OREGON CITY

FILE NO.: HR 14-10

REQUEST: Approval of a new single family residence in the Canemah National Register District.

REVIEWER: Christina Robertson-Gardiner, AICP, Planner

FIGURE	2
SCALE	1" = 40'
DRAWN BY	J. MCCONNAUGHEY
DATE	5/3/2014
JOB #	EVA 14-006

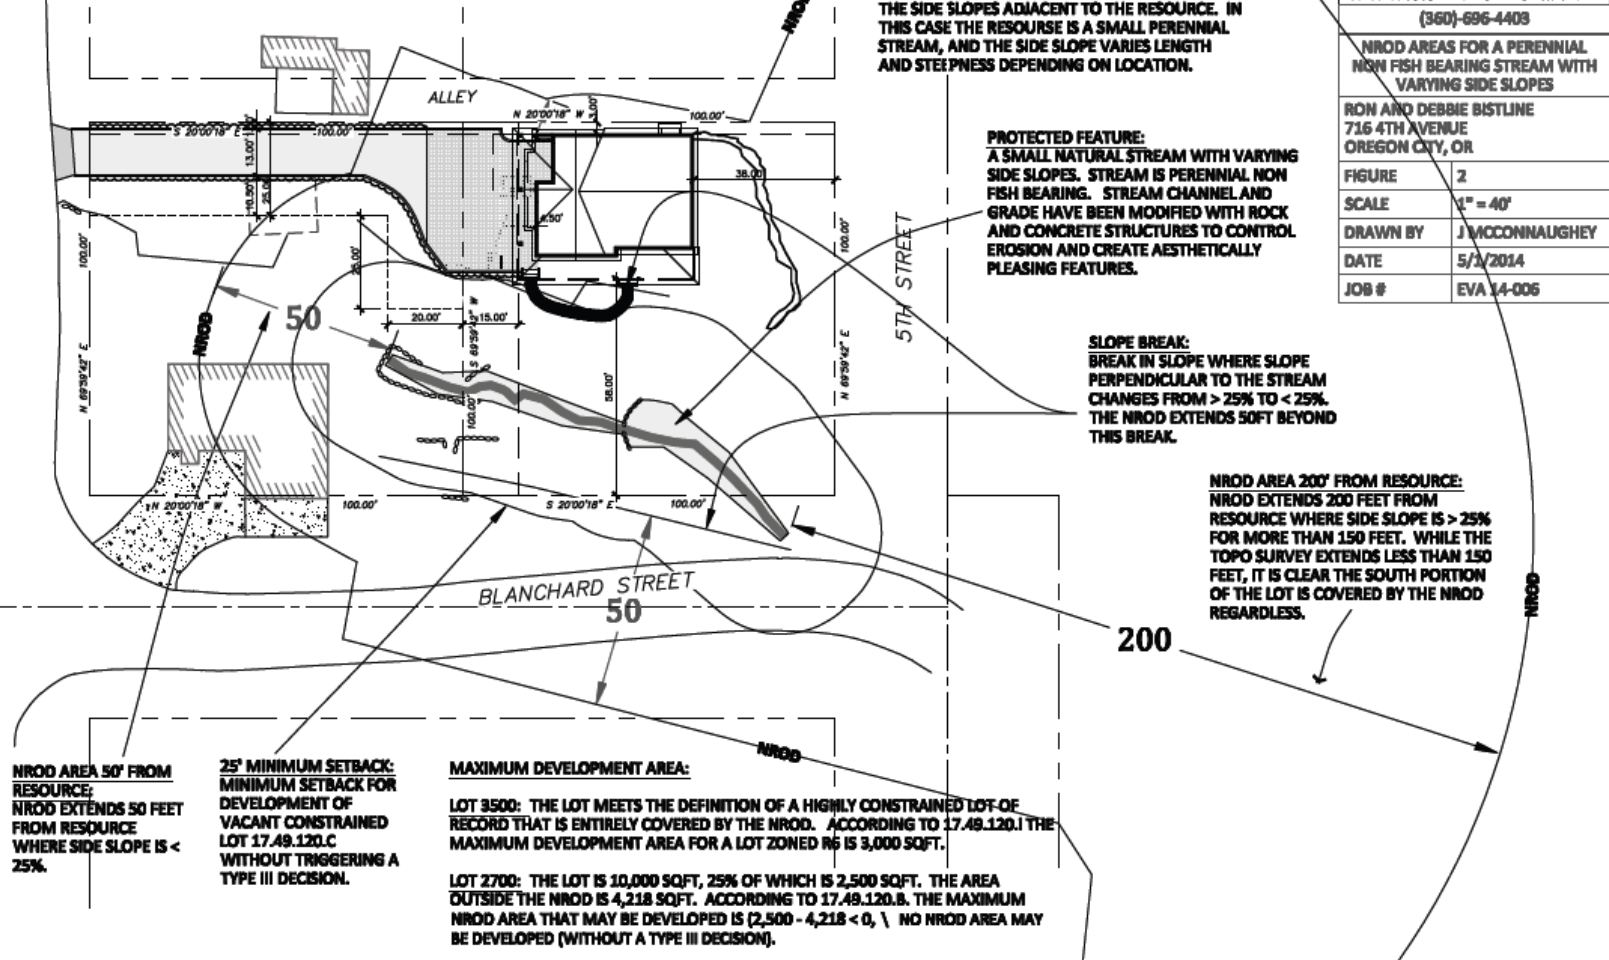
NATURAL RESOURCE OVERLAY DISTRICT (NROD):
TABLE 17.49.120.D DEFINES THE WIDTH OF THE NROD DISTRICT AS A FUNCTION OF THE TYPE OF RESOURCE AND THE STEEPNESS AND LENGTH OF THE SIDE SLOPES ADJACENT TO THE RESOURCE. IN THIS CASE THE RESOURCE IS A SMALL PERENNIAL STREAM, AND THE SIDE SLOPE VARIES LENGTH AND STEEPNESS DEPENDING ON LOCATION.

SLOPE BREAK:
BREAK IN SLOPE WHERE SLOPE PERPENDICULAR TO THE STREAM CHANGES FROM > 25% TO < 25%. THE NROD EXTENDS 50FT BEYOND THIS BREAK.

NROD AREA 200' FROM RESOURCE:
NROD EXTENDS 200 FEET FROM RESOURCE WHERE SIDE SLOPE IS > 25% FOR MORE THAN 150 FEET. WHILE THE TOPO SURVEY EXTENDS LESS THAN 150 FEET, IT IS CLEAR THE SOUTH PORTION OF THE LOT IS COVERED BY THE NROD REGARDLESS.
